AEOD/E133

SUBJECT: INADEQUACIES IN PERIODIC TESTING OF CE PWR REACTOR PROTECTION
SYSTEM (RPS)

REVIEW OF EVENT AT ST. LUCIE UNIT 1
ON NOVEMBER 30, 1980

Figure 1

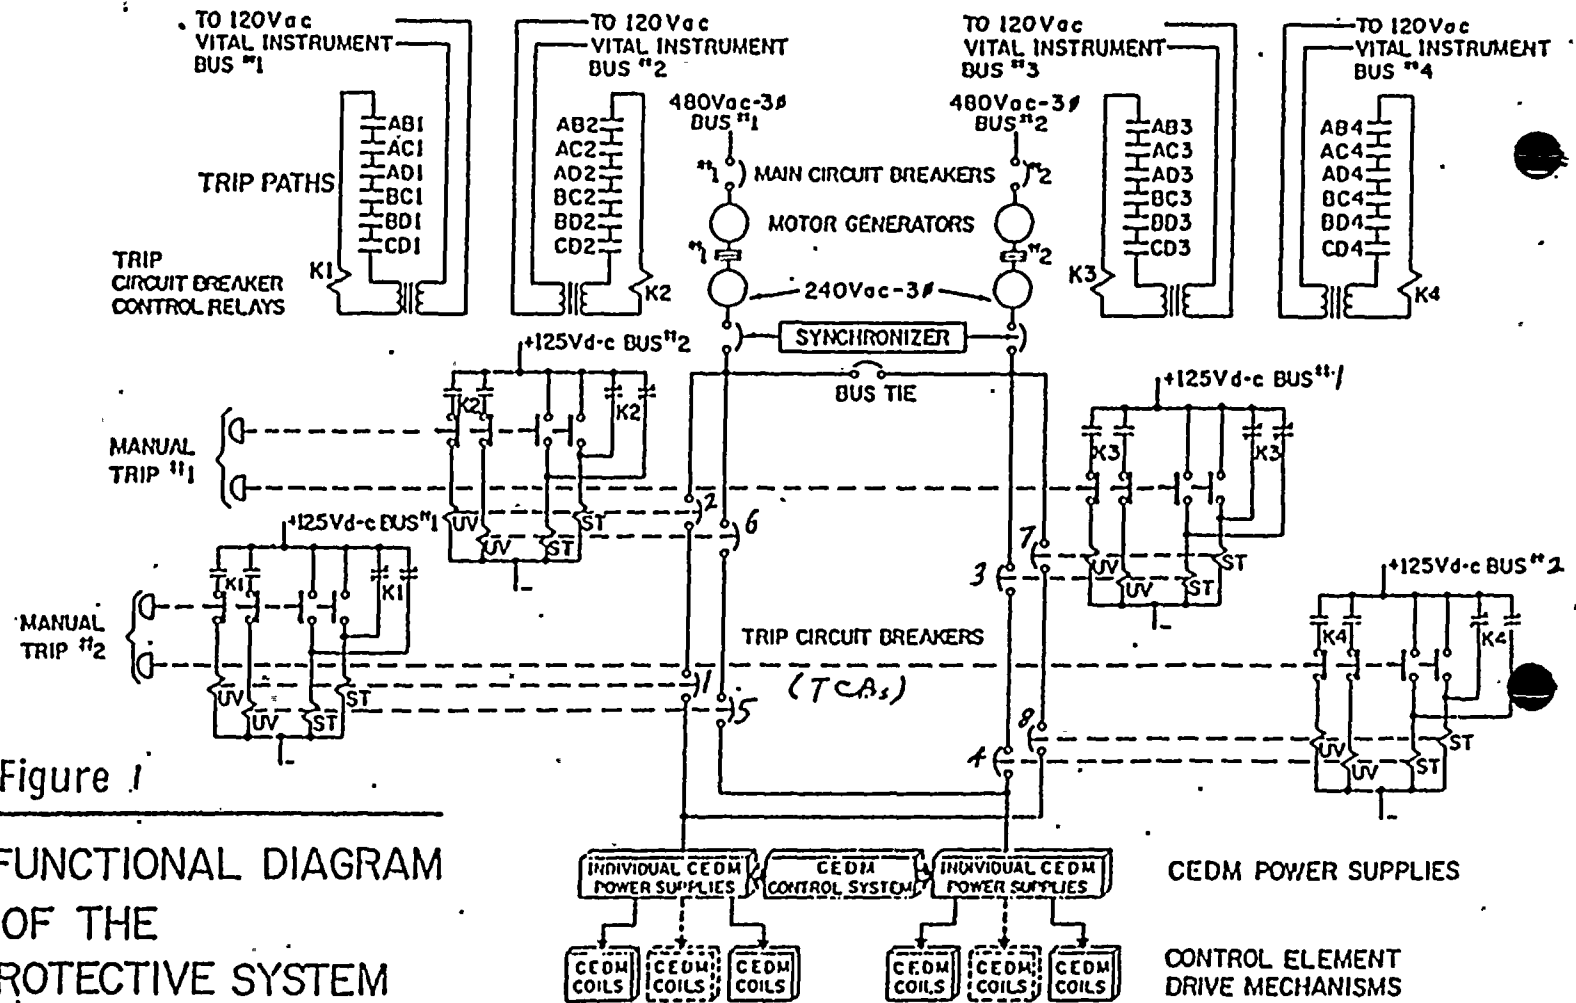
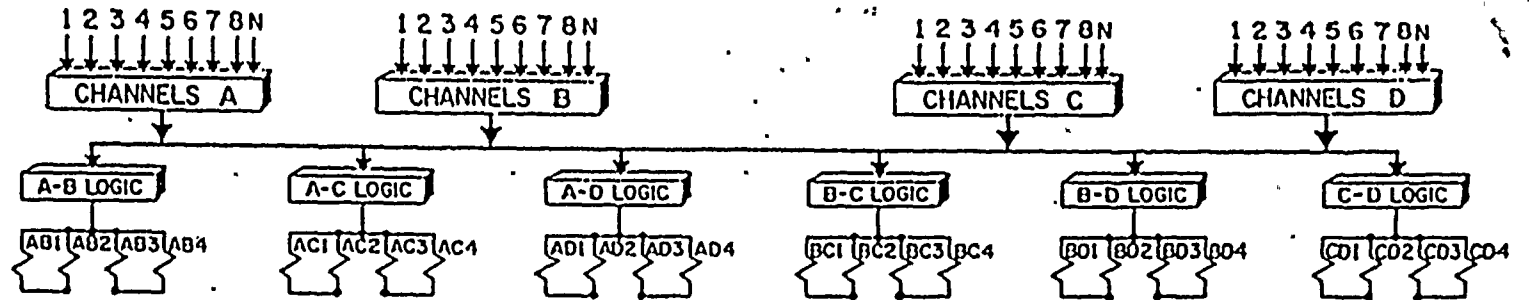
Referring to Figure 1, it can be seen that each TCB can be tripped by either the energization of the shunt trip coil or the de-energization of the undervoltage coil. During a reactor trip or CEDM power trip test these coils operate simultaneously causing the trip opening of the associated TCBs. During the event, however, upon de-energization of the 125 V dc control power the undervoltage trip coils did not open to trip TCBs 1, 3, 5, and 7. The arrangement of the RPS and the relevant test procedure appear to be similar for most of the operating CE PWRs.

The test procedure at St. Lucie has since been revised to test undervoltage coils by removing dc control power from them. A review of the reactor trip circuit breaker wiring diagram at St. Lucie apparently shows that a local trip circuit exists that uses the shunt trip device. A test using this local trip circuit is also being included in the St. Lucie procedure. The inclusion of these two tests (along with the existing testing) would verify the functionality of both the undervoltage trip and shunt trip of the TCBs.

We believe that similar modifications that would address the verification of function of the undervoltage trip and shunt trip of the TCBs should be included in the procedures used by other CE reactor licensees.
